# Technical Memorandum

**Re:** Spring Creek Hydrology Review

## Technical Memorandum

**To:** Della Schall Young, Young Environmental Consulting Group  
**From:** Jeff Weiss and Kallie Doeden, Barr Engineering  
**Subject:** Spring Creek Assessment Summary  
**Date:** September 6, 2019  
**Project:** 23101028.05

NOTES:

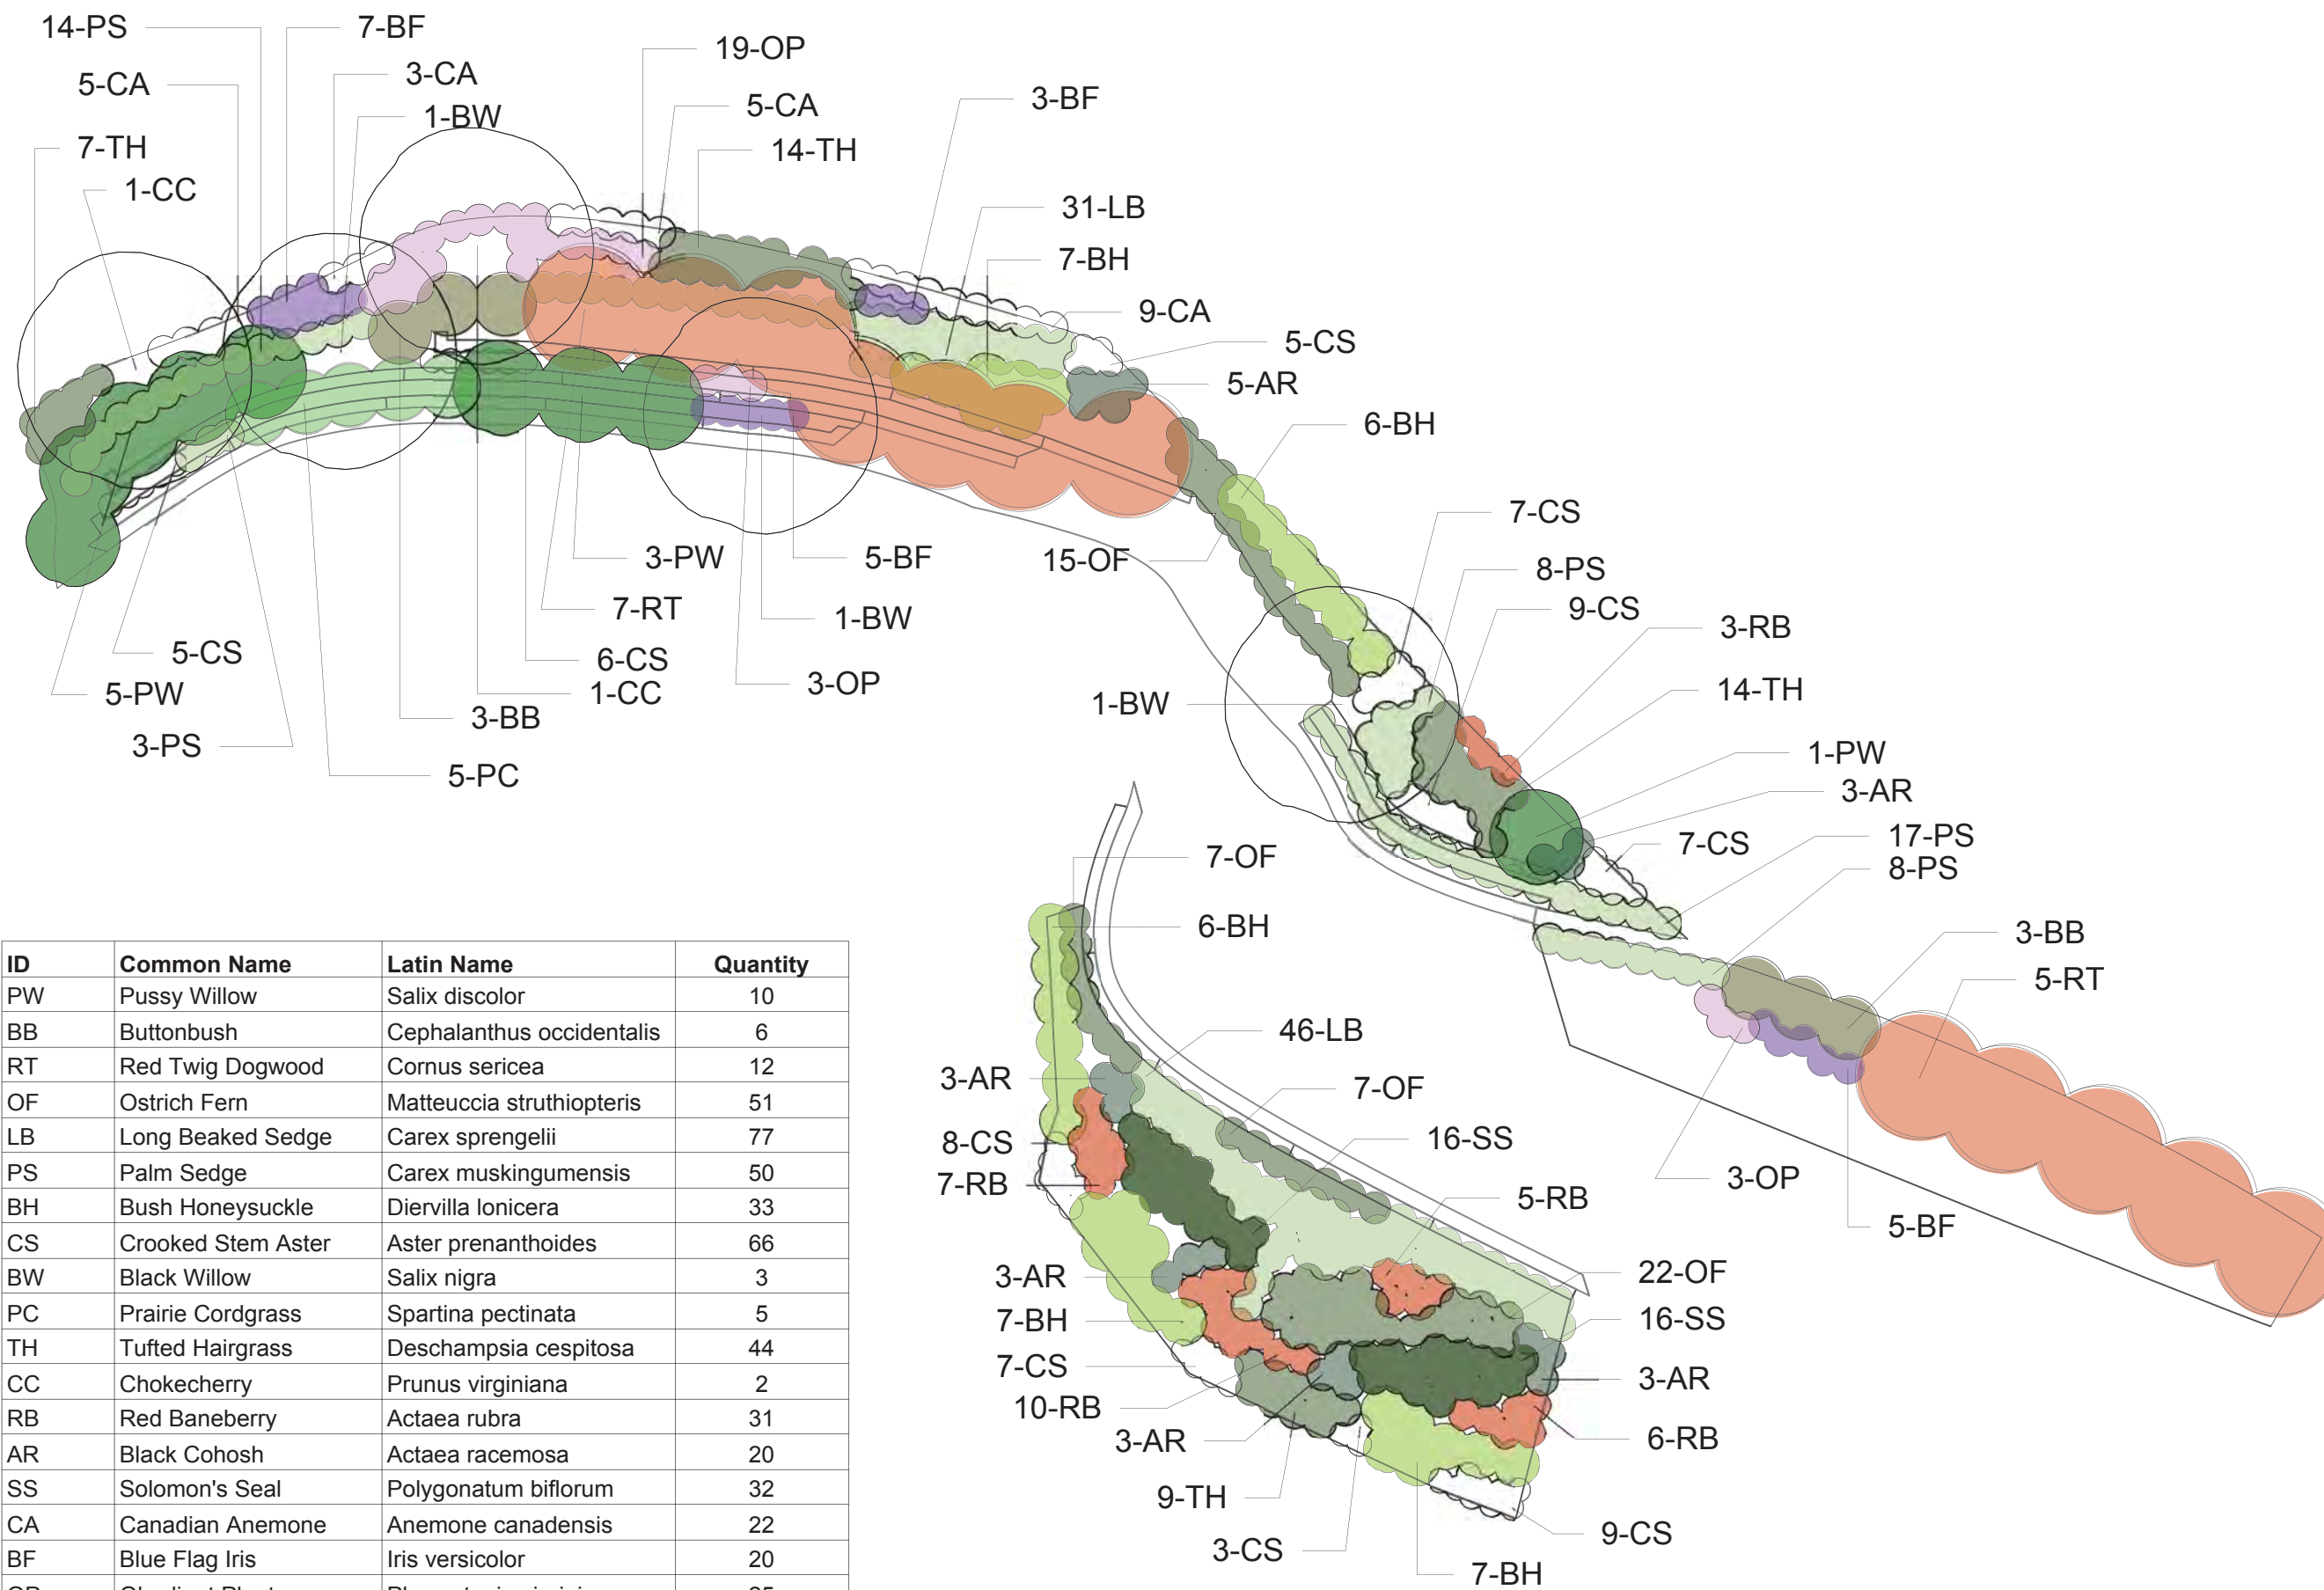
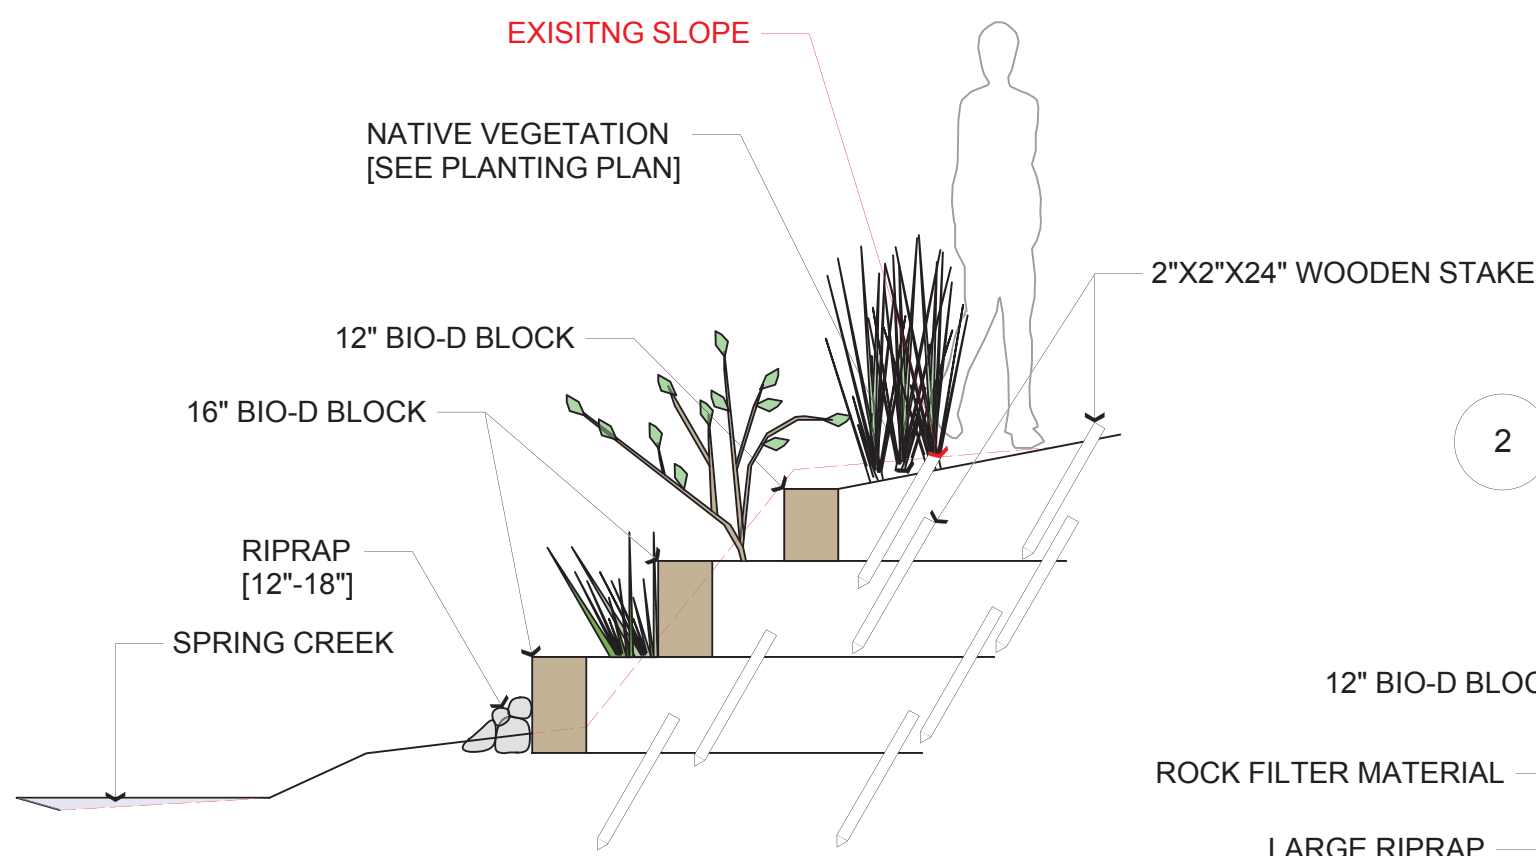
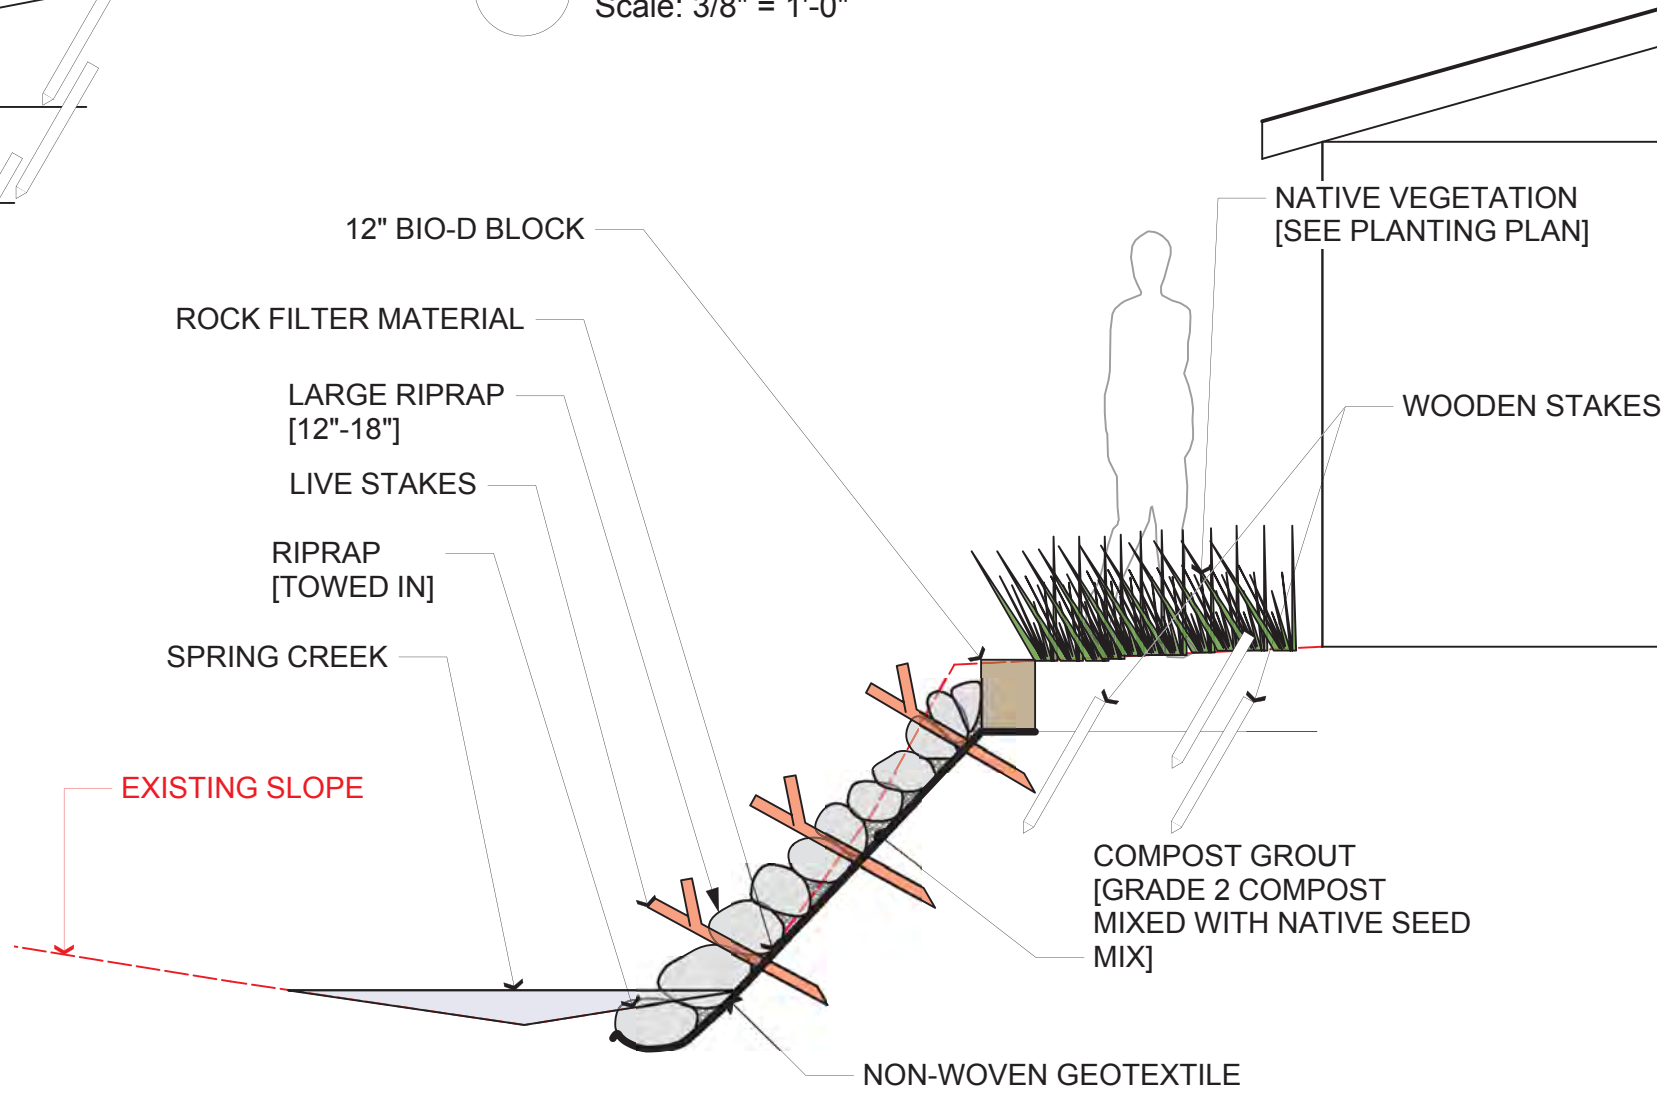
The Carver SWCD concept plan includes using riprap to armor the channel where banks are eroding, installing coir blocks in other areas with less stress, and revegetating with deep rooted species. Barr concurs with the general concept with the following considerations:

- At 404 Broadway, restore the channel to the previous alignment, which will provide additional space between the garage and the creek.
- Restore the previous channel alignment at 112 5<sup>th</sup> Street, with consideration of the modified hydrology draining to this location.
